DESCRIPTIVE REPORT

Registry No. H12141

General Locality Northern Glacier Bay

Sublocality Reid Inlet to Queen Inlet

Figure 3: H12141 Crosslines

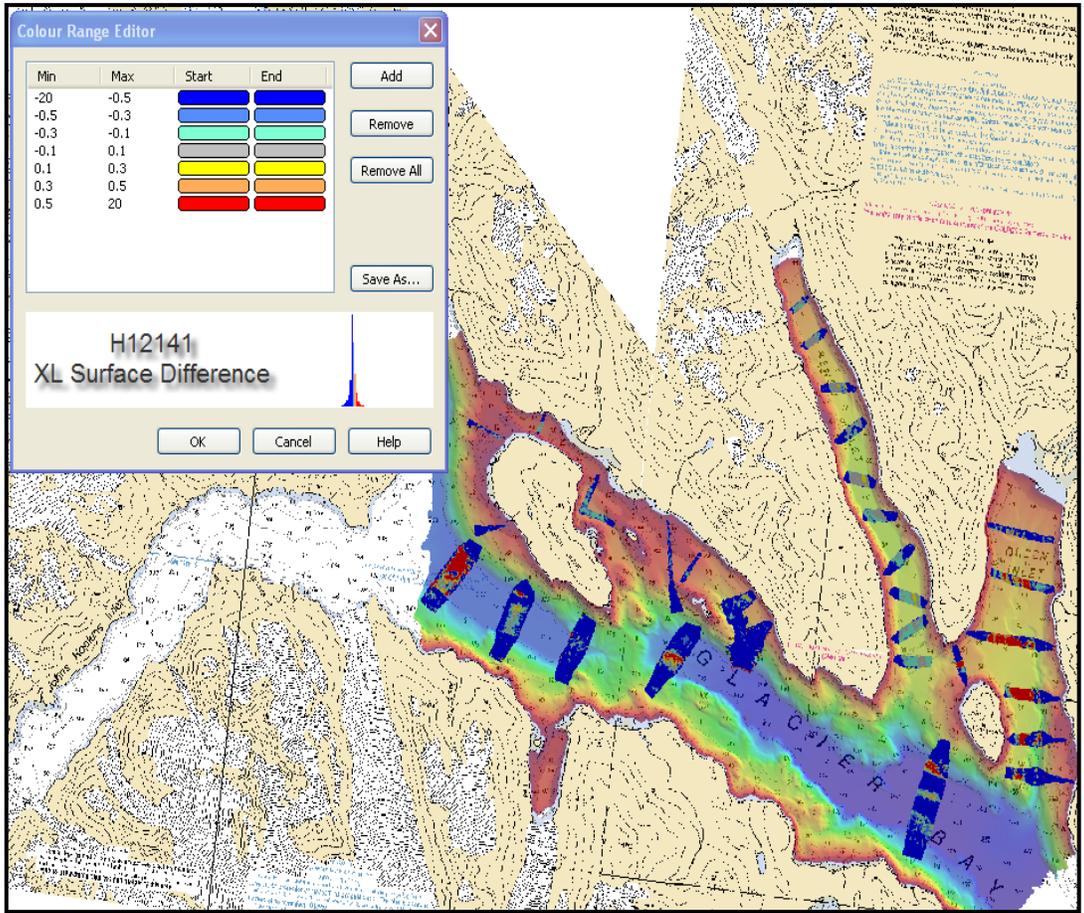
Surface differencing in CARIS BASE Editor was used to assess crossline agreement with main scheme data. Figure 3 below shows the color coded crossline difference surface in relation to the 16m main scheme surface. A fairly thorough check of difference values along all lines found most values to be 1 meter or less with only a very small number falling above 5 meters. The vast majority of the values

greater than 1 meter occur along the steep and deep nearshore sections while the flatter central portions show much better correlation.¹ CARIS Subset Editor was also used to assess crossline/main scheme agreement and supports the results observed with surface differencing.

-
- ¹ Concur with clarification. Higher disagreement is expected in areas of steep slopes. The data has been inspected and deemed adequate for charting.

Figure 4: Junction between H12141, H12140 and H12142

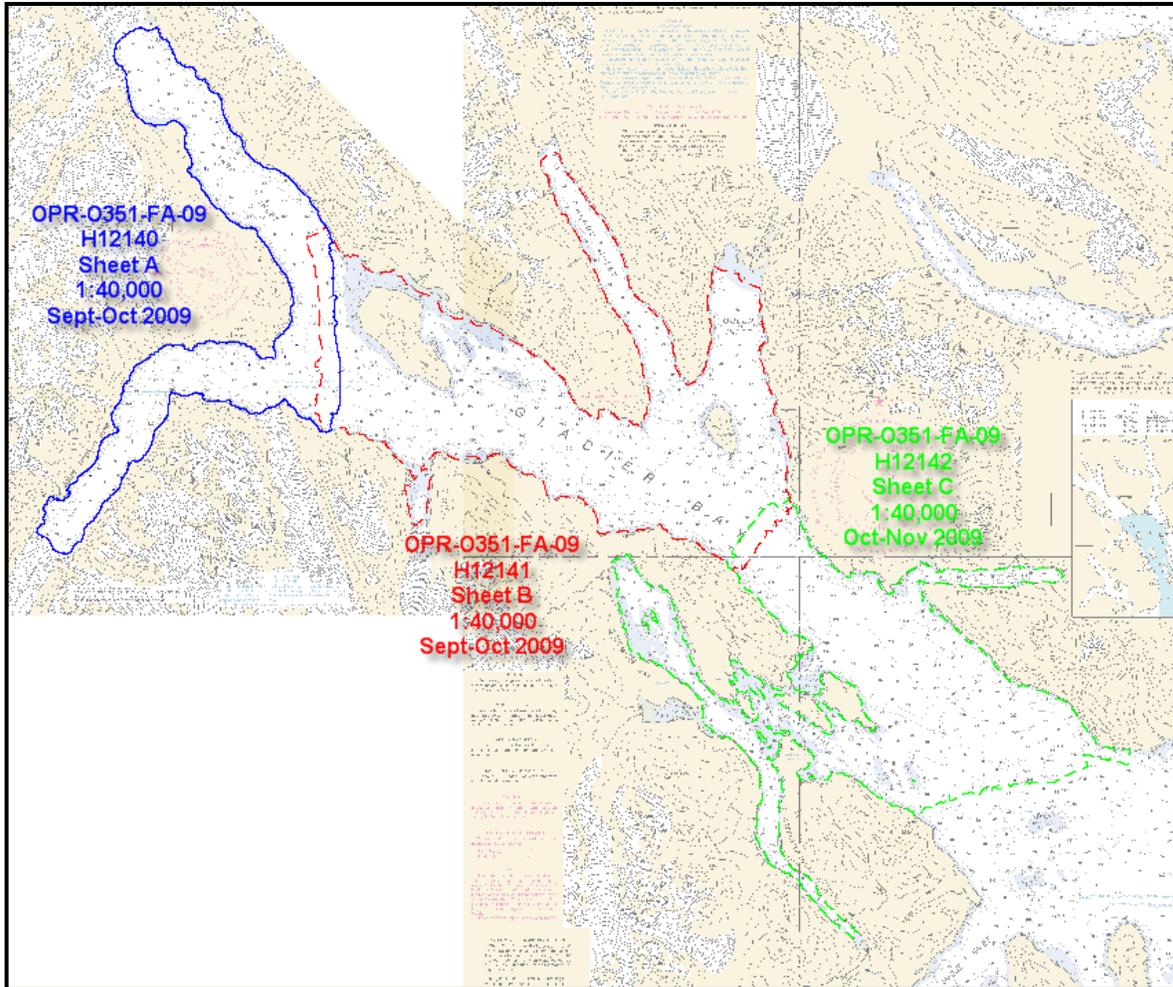
Survey H12141 junctions with H12140 and H12142, which are Sheets A and C, respectively, of the same project.² The area of overlap between the sheets was reviewed for consistency in CARIS Subset Editor and visually by the Hydrographer, and data were found to be in general agreement within one meter. The sheet limits and area of overlap for Sheets A, B and C are shown in Figure 4.

- ² A common junction was made with H12142 which has already been compiled. A common coverage junction was made with H12140. A common junction with the bathymetry and features will be made when that survey is compiled.

Figure 5: Holiday on 16m combined surface in 398 meters of water.

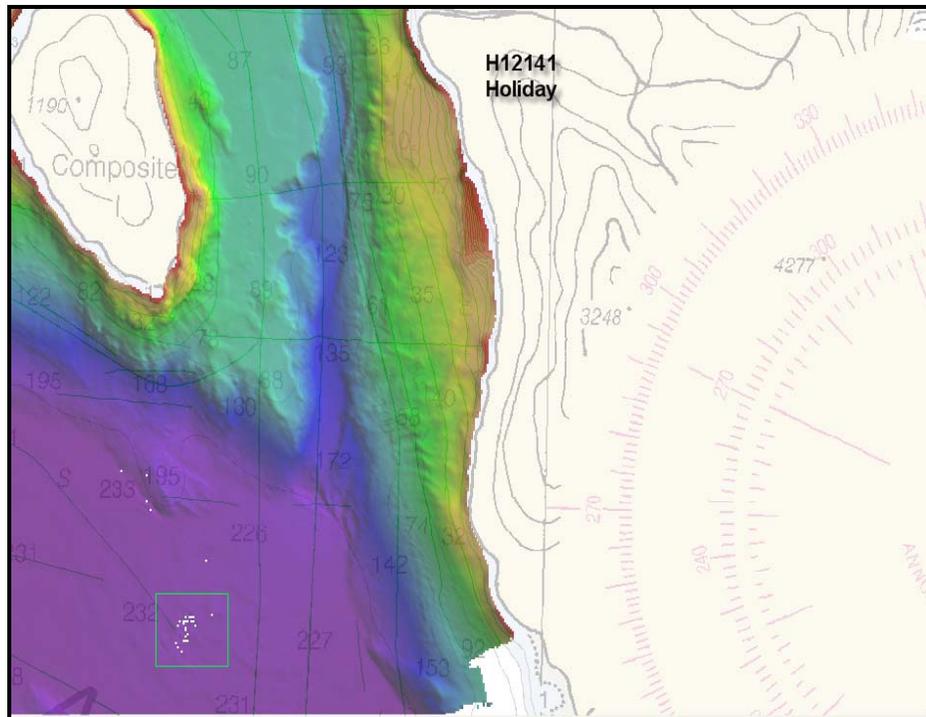
For holidays larger than 3 nodes across, the corresponding multibeam backscatter side scan was examined and no navigationally significant items were found. Figure 5 below shows the one holiday, which occurs in 398 meters of water. Due to the great depth and relatively flat nature of the seafloor, as indicated by surrounding coverage, this holiday is not of navigational significance.³

- ³ Concur with clarification. The holiday was not preserved in the HCell coverage.
- ⁴ The positioning is within specification and the data is adequate for charting.

Figure 7: H12141 designated soundings.

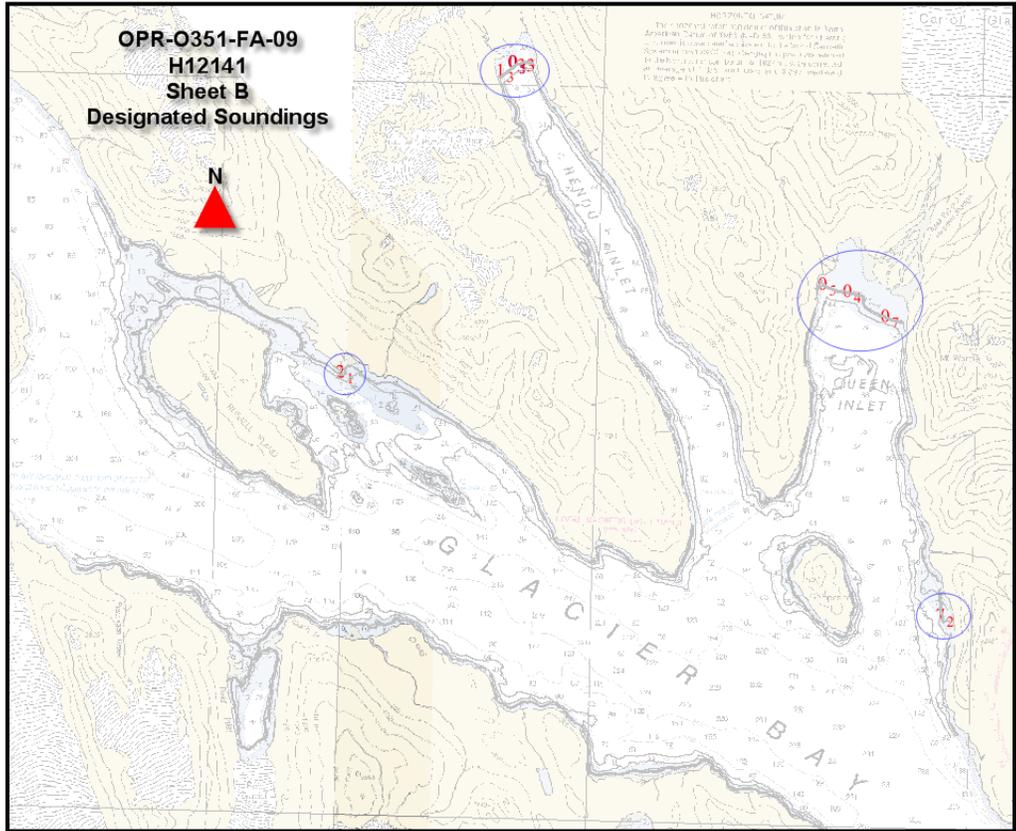
Eight soundings have been designated for H12141 (Figure 7). Of these, seven were designated to preserve shoal depths and one was submitted as a DTON. Three of the eight including the DTON are located at the head of Rendu Inlet, which has seen rapid shoaling due to glacial outwash, and three are at the head of

Queen Inlet which is represented as “unsurveyed” on the existing chart. All of the designated soundings are close ashore.⁷

- ⁷ Designated soundings are included in the HCell as proximity to features at chart scale allows.
- ⁸ The data is adequate for charting.
- ⁹ A 16-meter combined surface created during the SAR was used as the basis for compilation.

Figure 8: IHO child layer for combined surface.

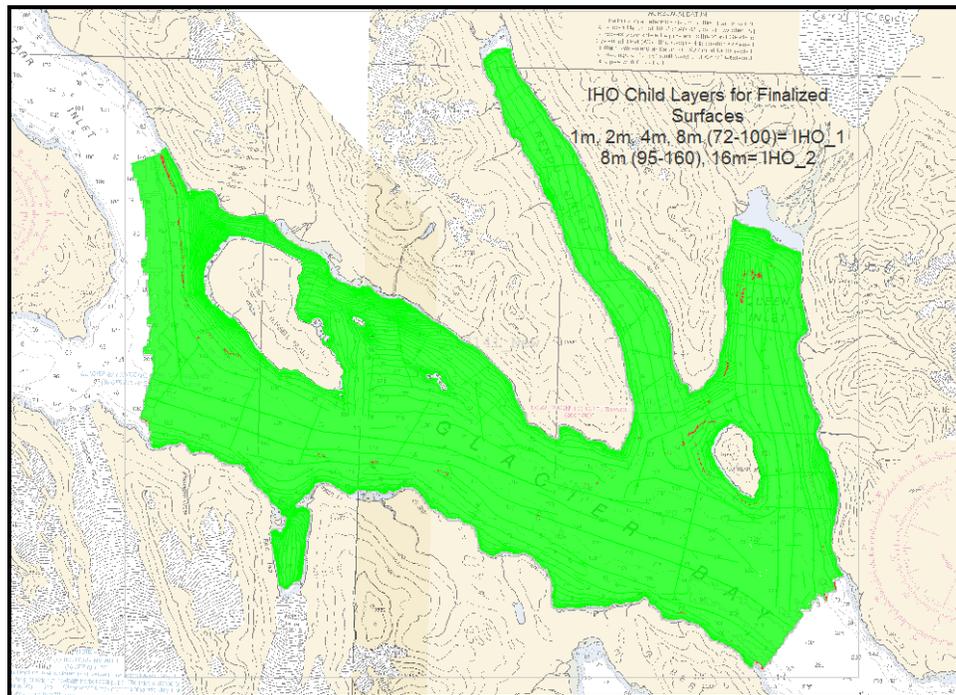
A color map was used to assess the IHO uncertainty difference layer (green for positive values (pass) and red for negative values (Fail)). Figure 8 shows the IHO child layer for the combined surface which was created from the finalized surfaces listed in the figure. This layer indicates that the CARIS-reported

uncertainty of greater than 95% of the nodes from all finalized surfaces is within the vertical error tolerances allowed by IHO Order 1 and/or IHO Order 2 standards for their depths and therefore meets IHO accuracy standards.⁸

Figure 9 : Sounding (fathoms) discrepancies at head of Rendu Inlet

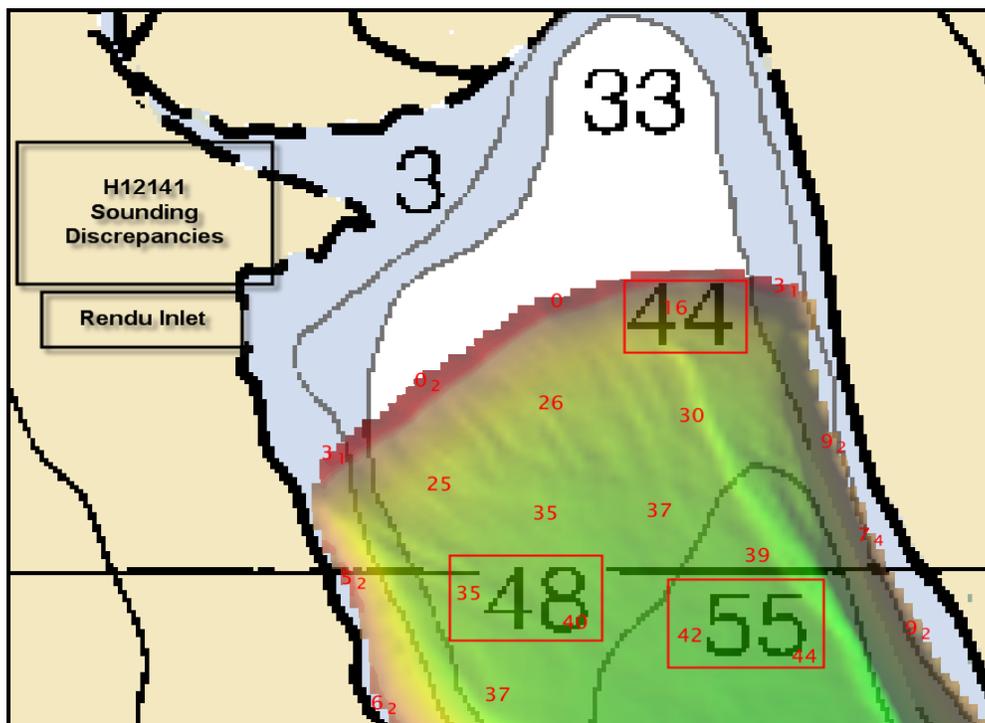
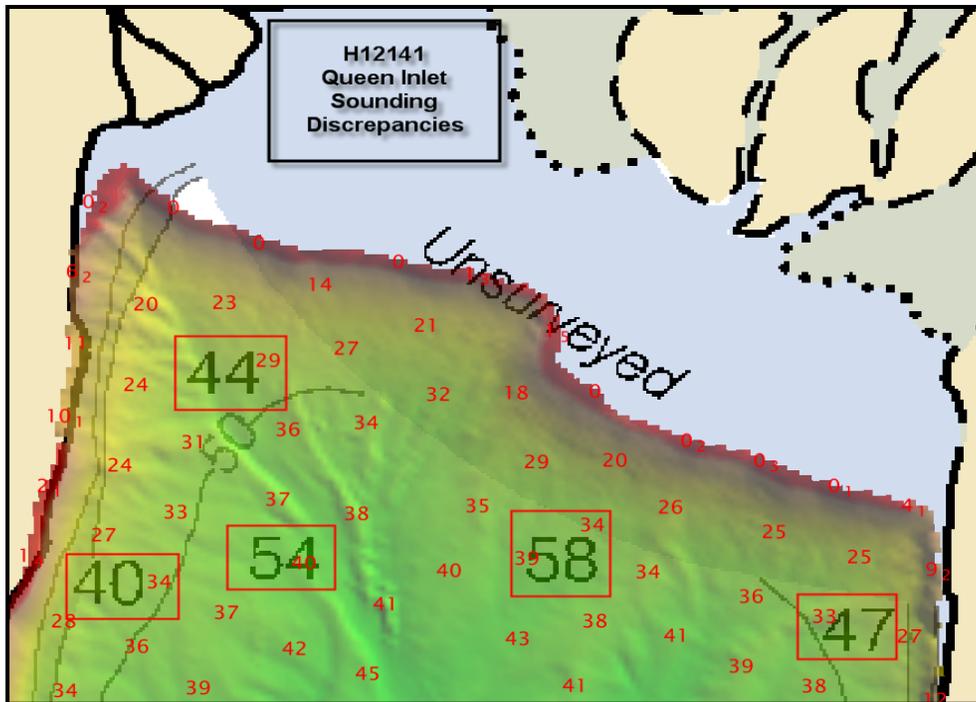
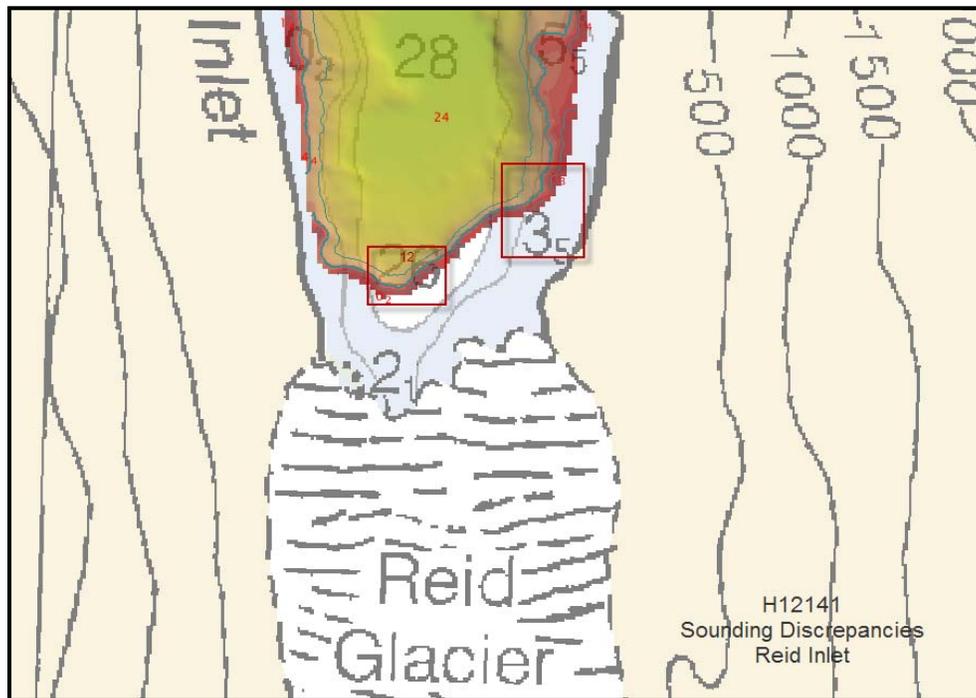
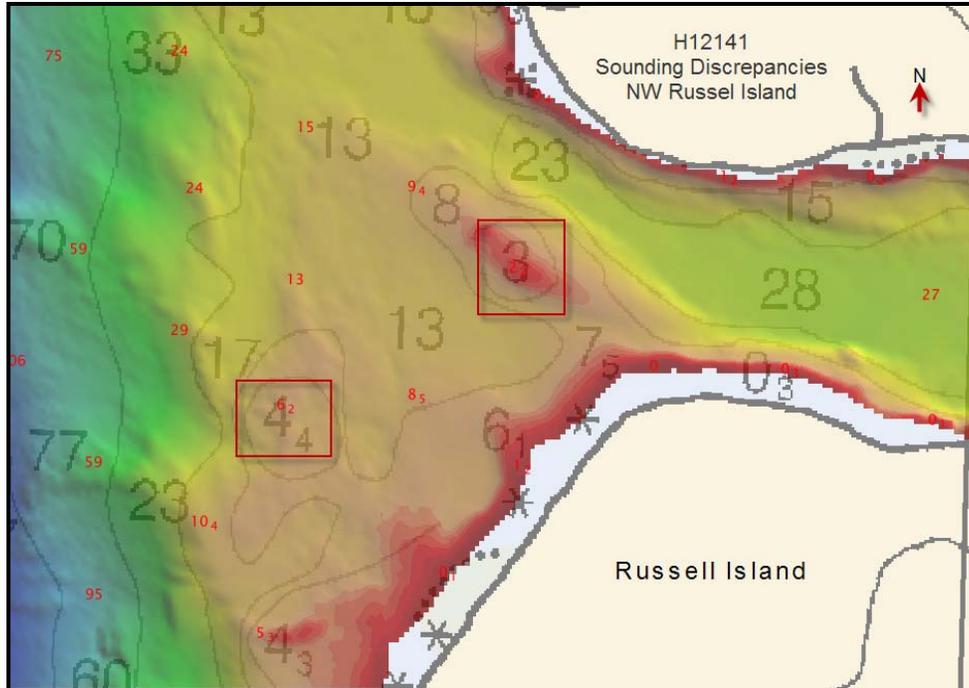
The head of Rendu Inlet, Queen Inlet and Reid Inlet show significant discrepancies with Chart 17318 due to shoaling as a result of the rapid sediment build up from glacial outwash streams. Figure 9 shows the difference between survey H12141 soundings (red) and charted depths (black) at the head of Rendu Inlet, figure 10 the difference at the head of Queen Inlet and figure 11 the head of Reid Inlet. Charted contours are also erroneous at the head of Rendu, Queen and Reid Inlets. Figure 12 shows sounding variance from northwest of Russell Island.¹⁴

The head of Rendu Inlet was classified as a DTON due to the navigationally significant difference with the chart.¹⁵

- ¹³ H12141 was submitted to Pacific Hydrographic Branch for review and compilation.
- ¹⁴ Chart depths and features as depicted in the HCell.
- ¹⁵ The location of the reported DTON is noted in the HCell.

Figure 13: Change “Unsurveyed” at head of Queen Inlet

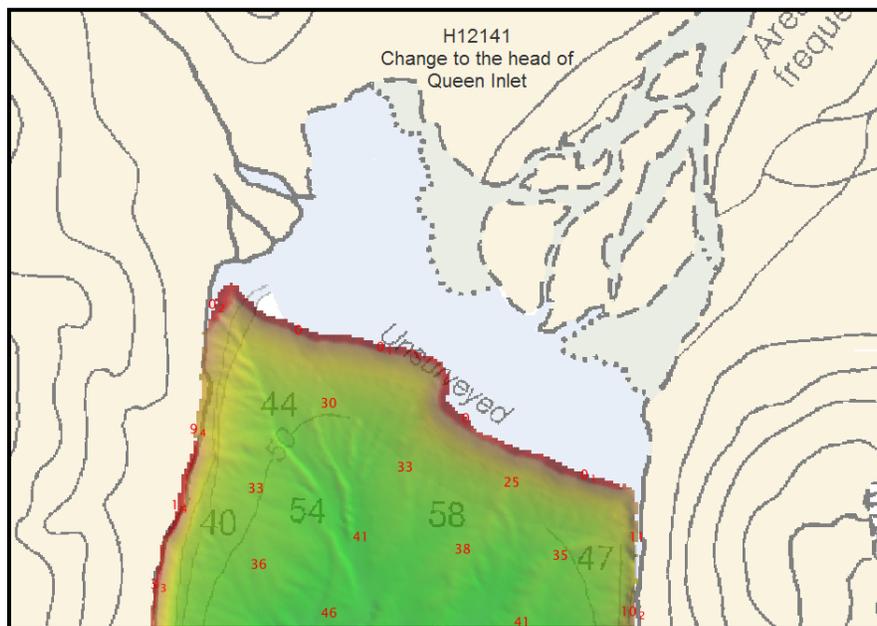
The current survey has defined the shoal edge of the extensive sediment flat at the head of Queen Inlet. This area is marked as “Unsurveyed” on the current chart (see figure 13). It is recommended by the Hydrographer that the “Unsurveyed” be removed and the new chart reflect the actual configuration of upper Queen Inlet.¹⁶

- ¹⁶ Do not concur. It is recommended in the HCell that the “Unsurveyed” label be repositioned to reflect the limits of the new survey data.
- ¹⁷ See attached DTON Report.
